Oil Suction Manifold

EPA07/10/GHG14 HDEP ENGINES

Oil Suction Manifold Weld Failures

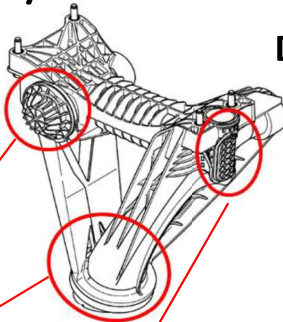
- Broken Oil Suction Manifolds due to welding failures have been identified in the field. Can lead to low oil pressure codes.
- Occurring at the end cap (most), valve cover (some), & suction nozzle (few).
- Engines built in Mar-14 & Apr-14 are most susceptible to this failure.
- ZEUS 1598287 & FSPR 29142.

- Vendor implemented changes (melt position sensor) on 24-Oct-14. Effective with approximate engine s/n HDE0301463 built on 1-Dec-14.
- Further process improvements (flow rate system) implemented in both EK-Germany and EK-Canada during CW19/2016 (approximately 9-May-16).

- Replace oil suction manifold. Reference the *EPA07/10/GHG14 Engine Manual* (DDC-SVC-MAN-0081).
- **Field Service Campaign 18M3** for engines built in Mar-14 & Apr-14 released in Jul-18. 18M3 is 67% complete as of Jun-19.
